CIRCUIT COMPARISON

ChryslerScanner

Original schematic -> current circuit sets

Original: Daniel Laszlo, revision 2.4.0-1, 2026-01-05. Current: Rev C, 24 pages / 329 circuit-probe endpoints.

08 PCI +7.5 V supply

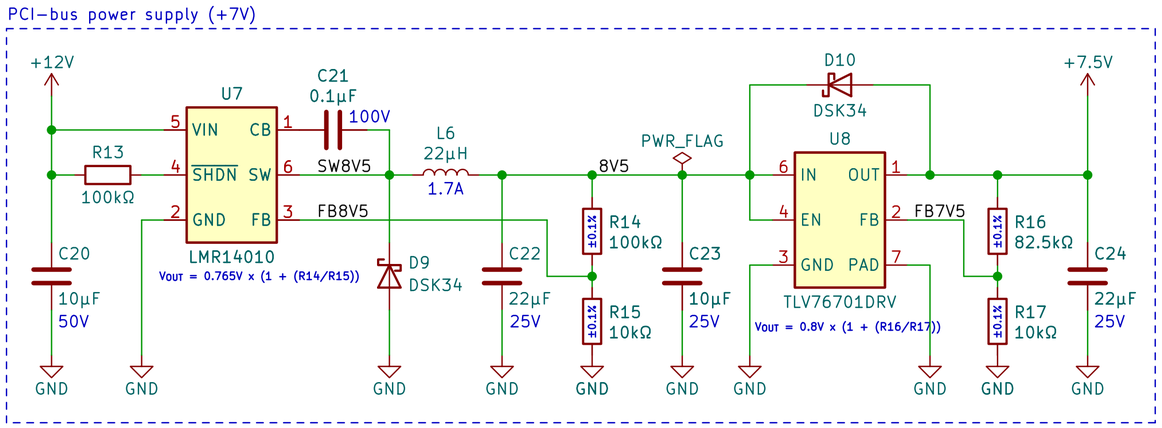
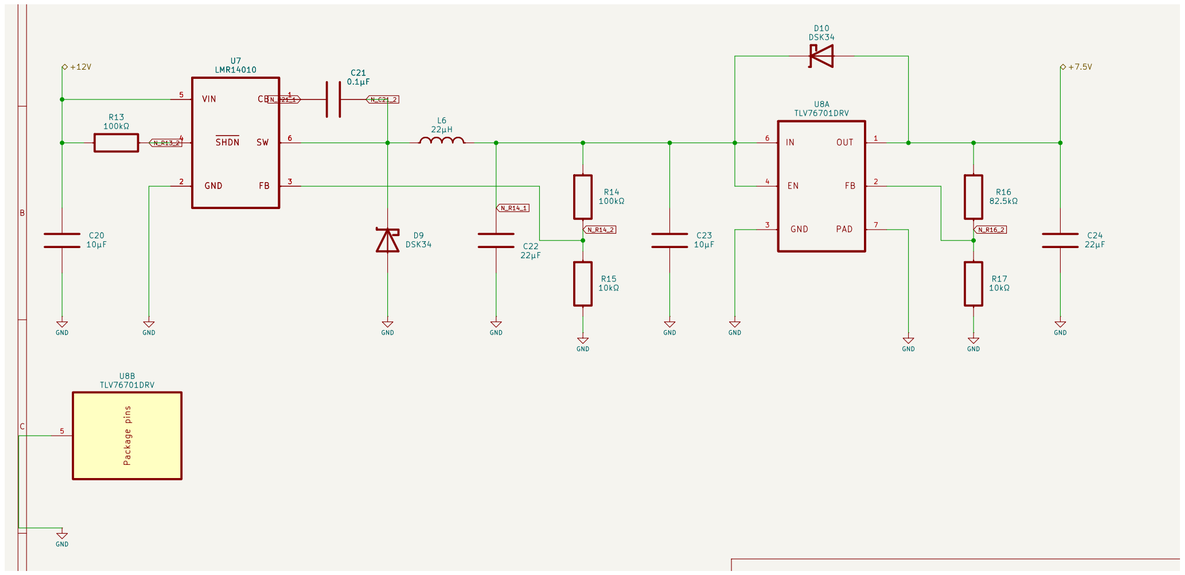
- U7, U8, L6, D9/D10 and their feedback/output filters retain the original PCI supply function.
- This rail is distinct from the new PCI_VCC clamp supplying the comparator. See comparison 29.

09 PCI / J1850 receiver and transmitter

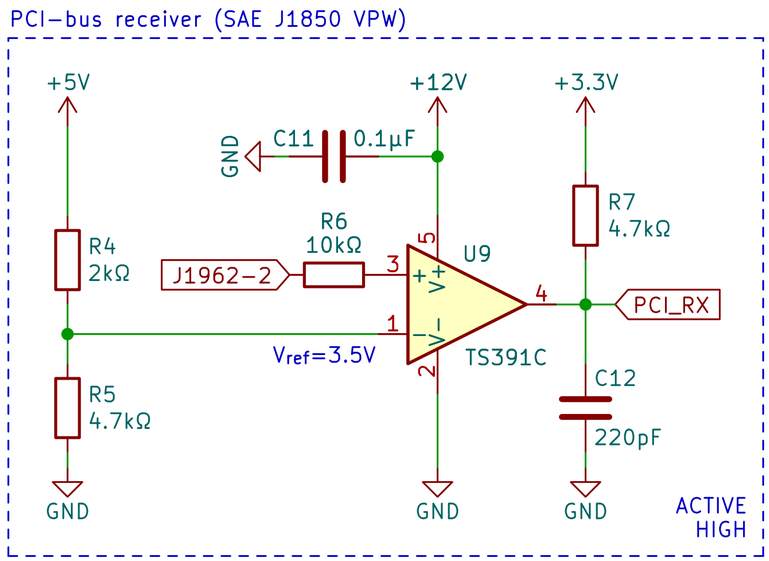
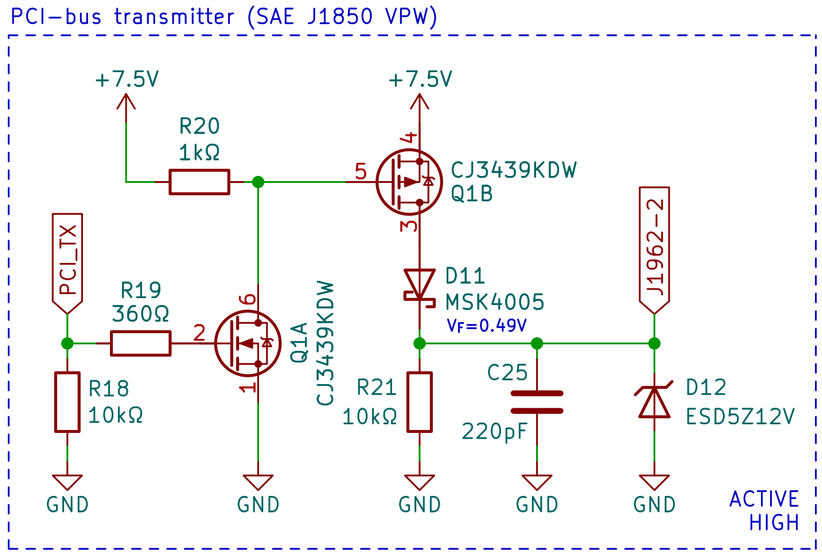
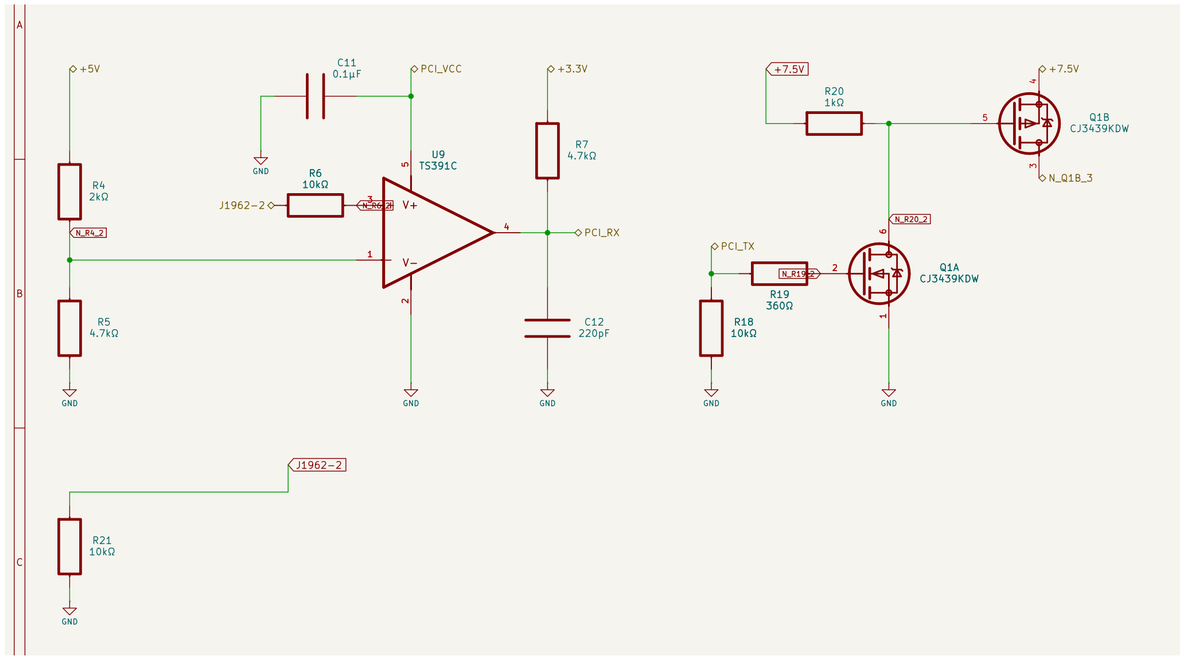
- U9, Q1, R4-R7 and R18-R21 retain the PCI receive/transmit functions.
- U9.5 and C11.2 now use the separately clamped PCI_VCC rail instead of direct +12V. C25 and D11/D12 are displayed on the connector/protection page.

10 ESP32, RF and local decoupling

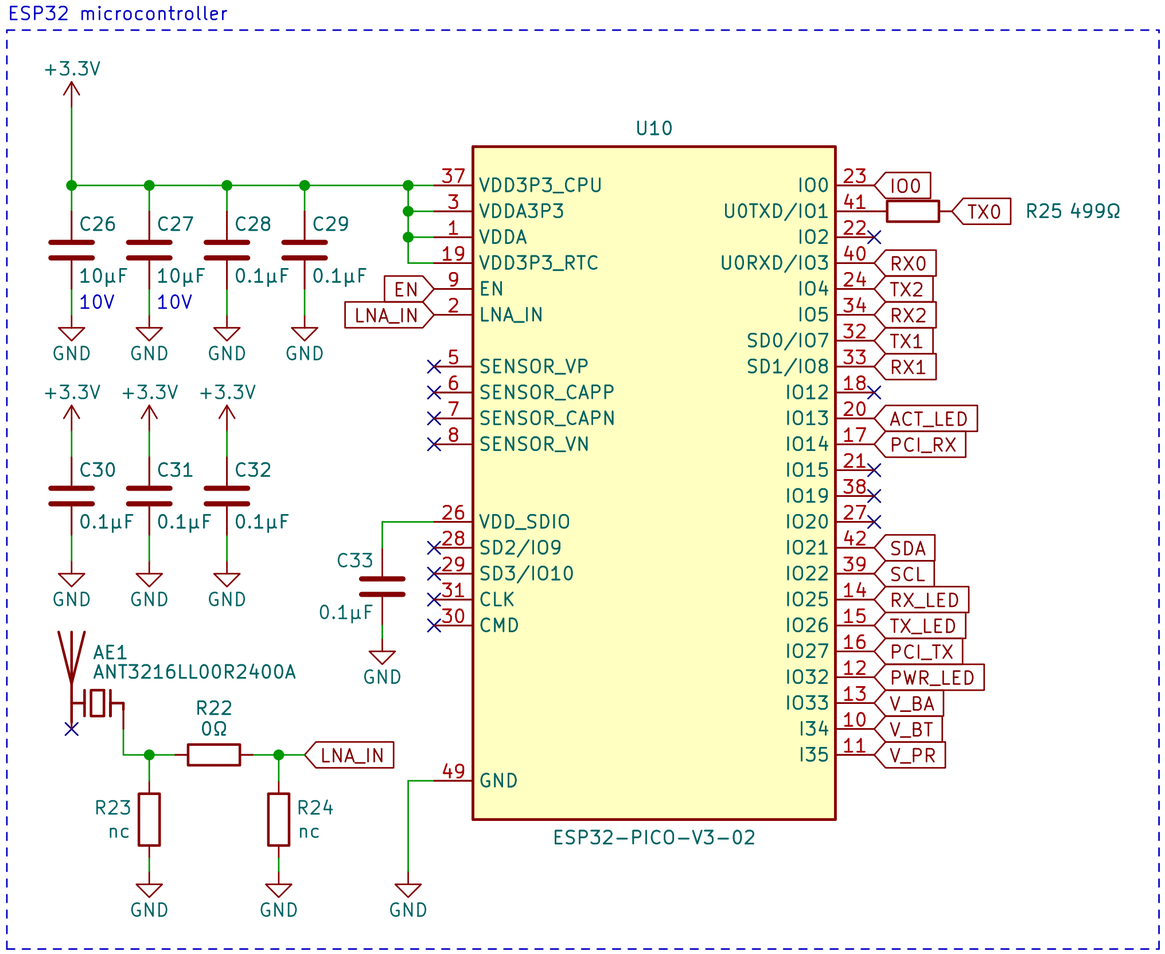
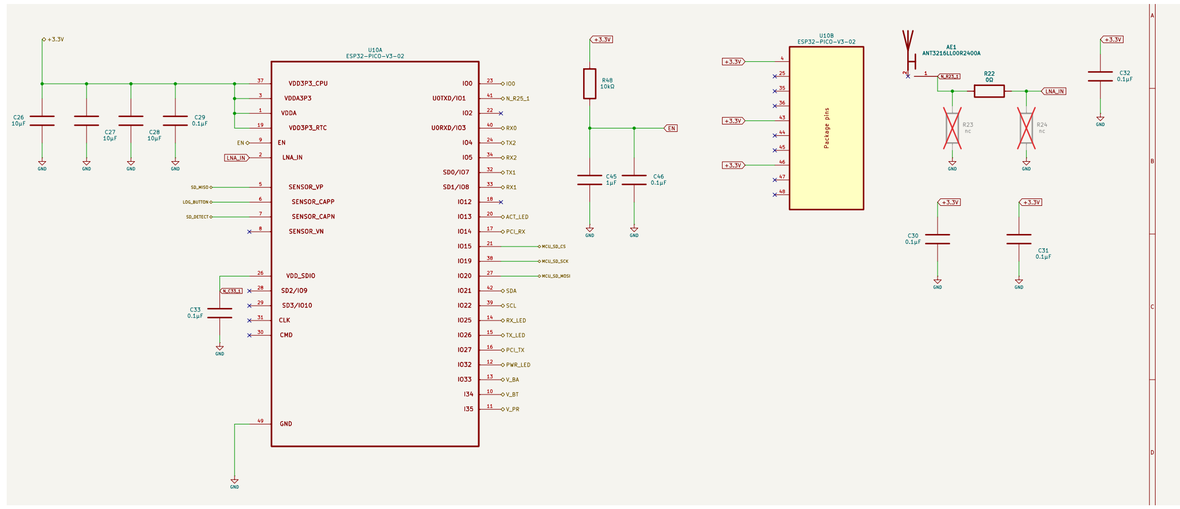
- The original ESP32 package, RF network and existing functional pin assignments remain.
- Previously unused U10 pads 5, 6, 7, 21, 27 and 38 now serve SD and logging functions. ACT_LED is assigned exclusively to the supervised health heartbeat; legacy activity firmware is incompatible.

11 USB / UART bridge and USB ESD

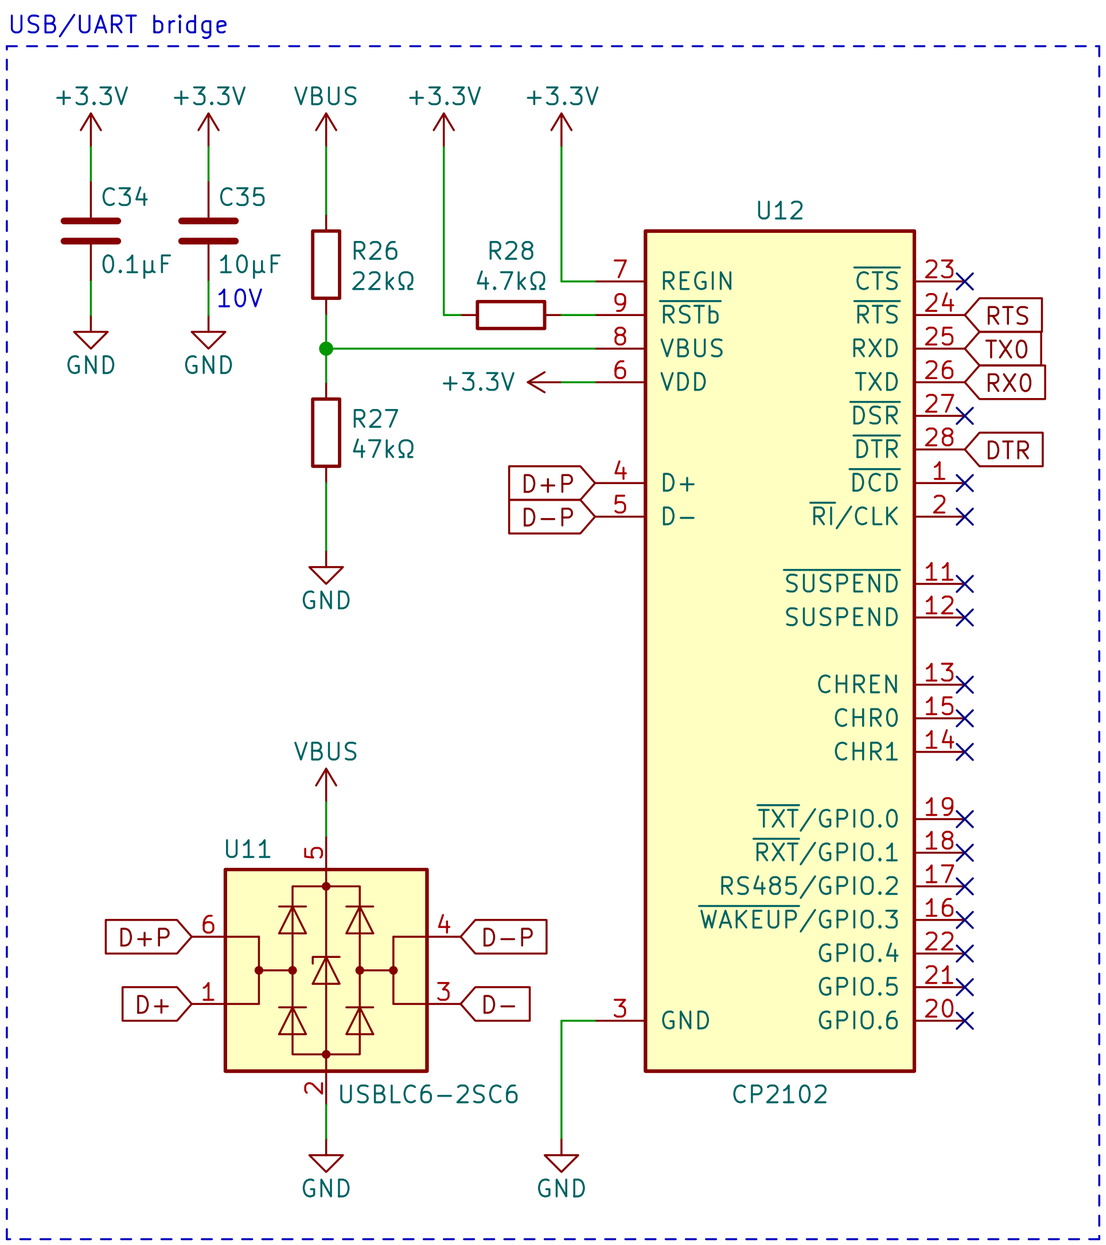
- The classic CP2102 is retained; this is not a CP2102N conversion. U11 retains the USBLC6 protection function.
- The current symbol drawing is split into several units belonging to U12. USB-C contact mapping and CC termination are intentional additions.

12 Reset, boot and automatic programming

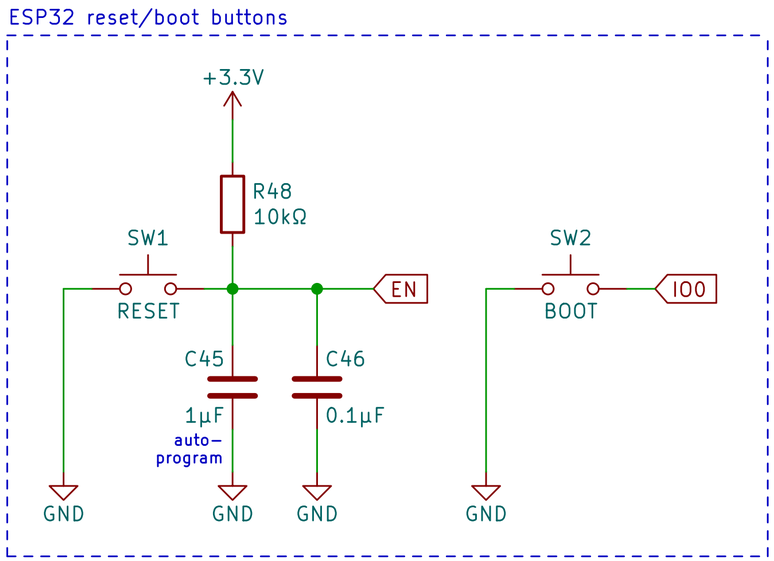
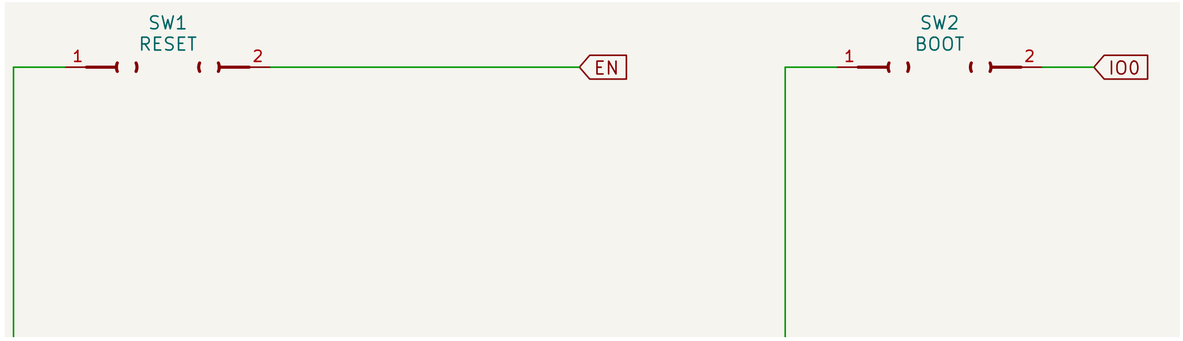
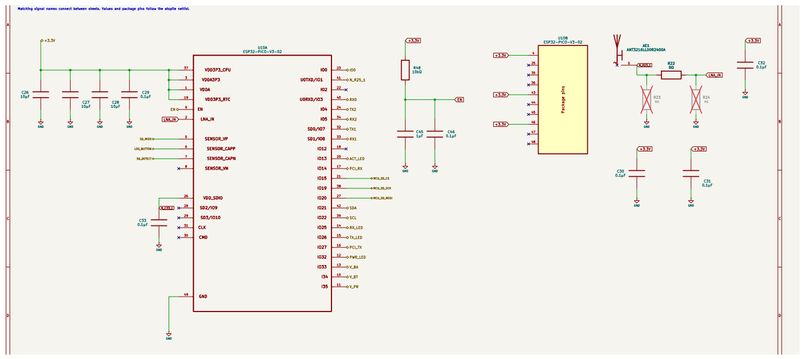
- Buttons and automatic programming are grouped with USB; the reset resistor/capacitors remain on the MCU sheet.
- Q5 multi-unit drawing and named EN / IO0 / RTS / DTR nets correspond to the original automatic programming topology.

13 SCI TX14 and TX9 paths

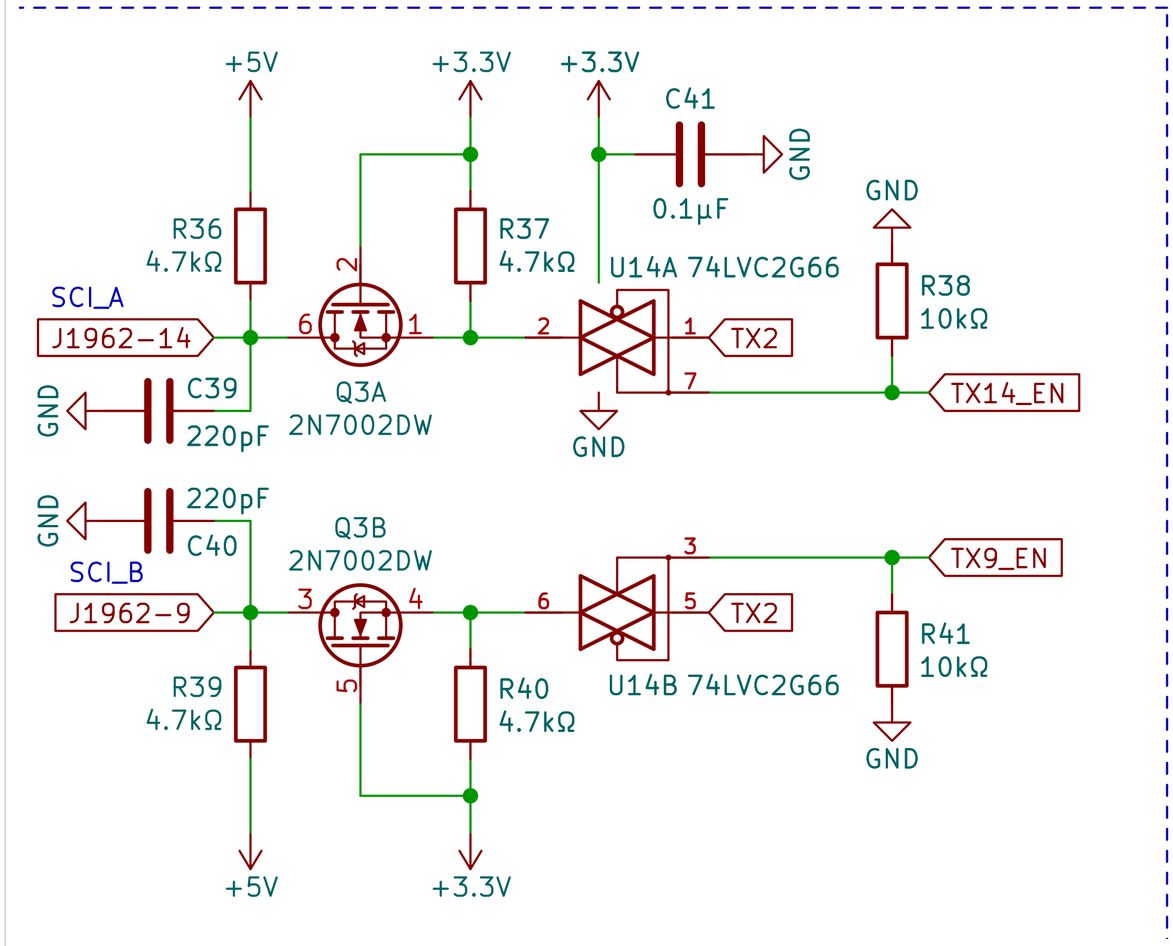
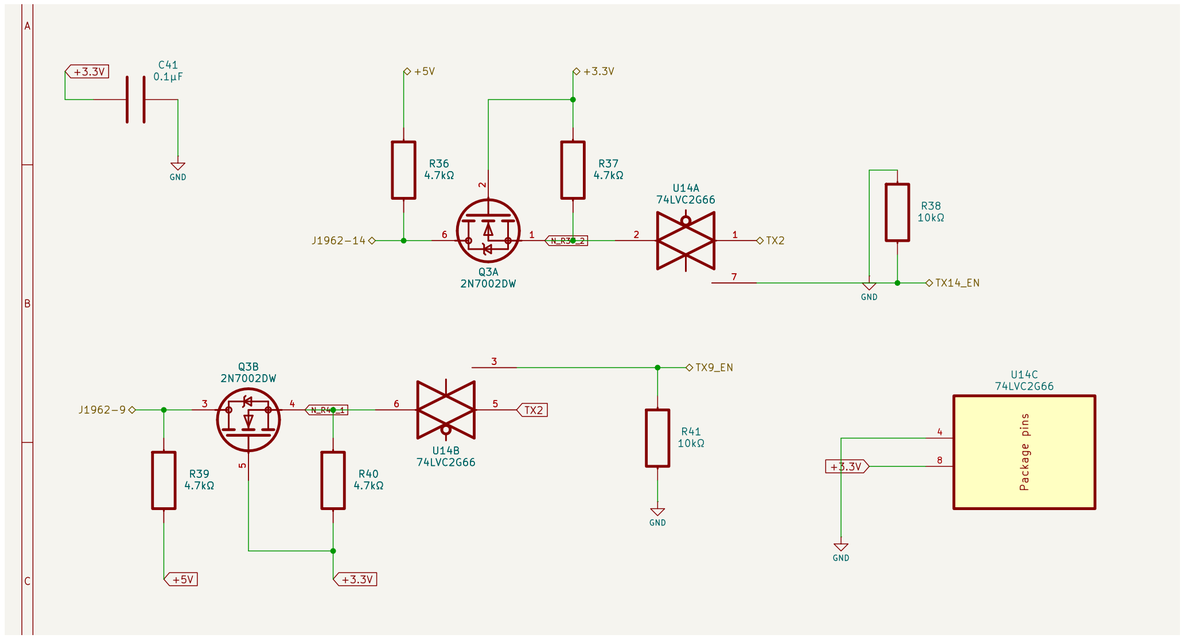
- Q3, U14, R36-R41 and C41 correspond to the original two transmit paths.
- C39 and C40 are now grouped on the connector/protection page. Vehicle pins 14 and 9, enable names and shared TX2 function remain identifiable.

14 SCI TX6 / TX12 and selectable bias

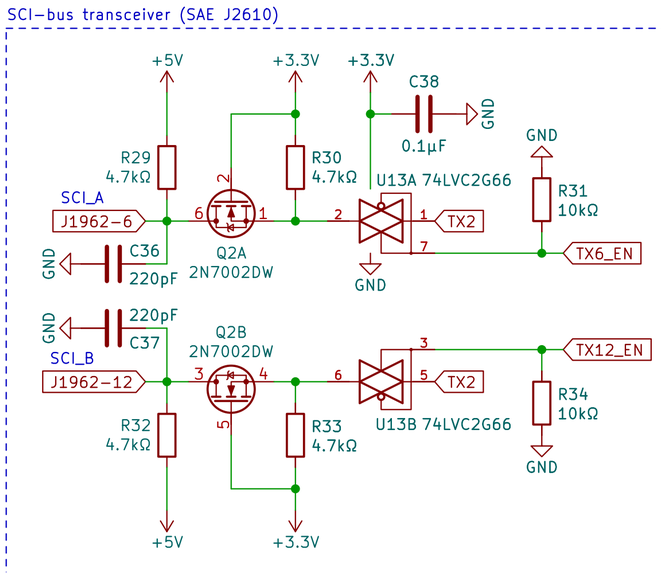
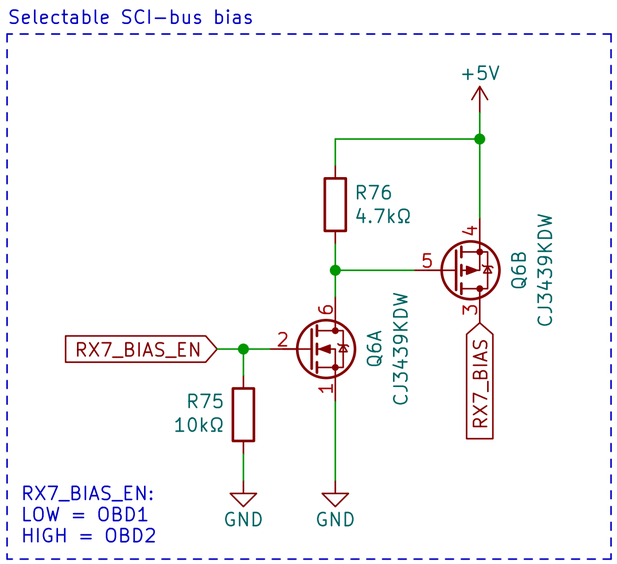
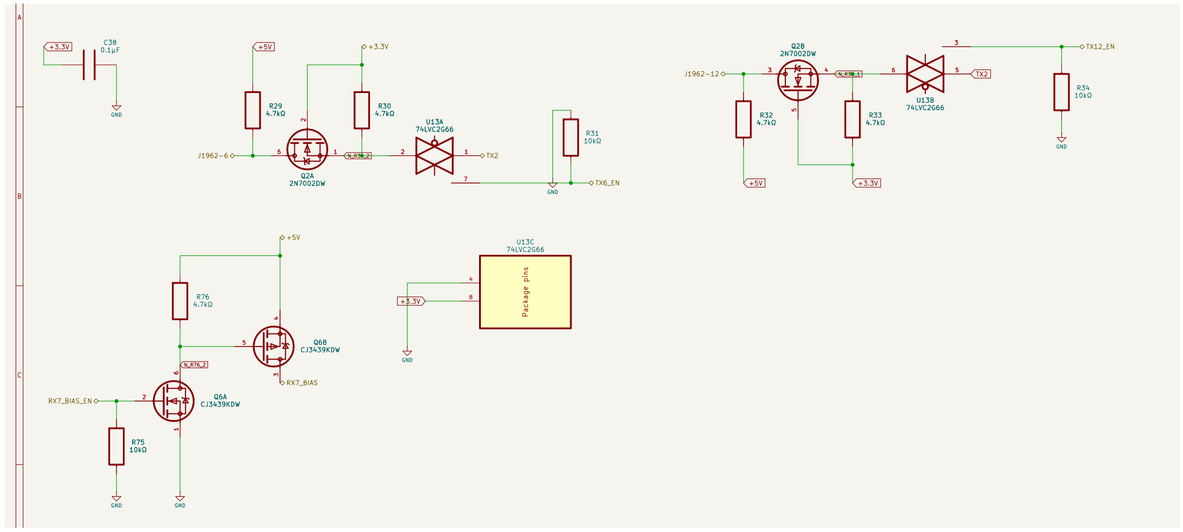
- Q2/U13 transmit switching and Q6/R75/R76 selectable bias are grouped on one page.
- C36/C37 are on connector protection. RX7_BIAS_EN, TX6_EN, TX12_EN and the corresponding vehicle pins retain their original roles.
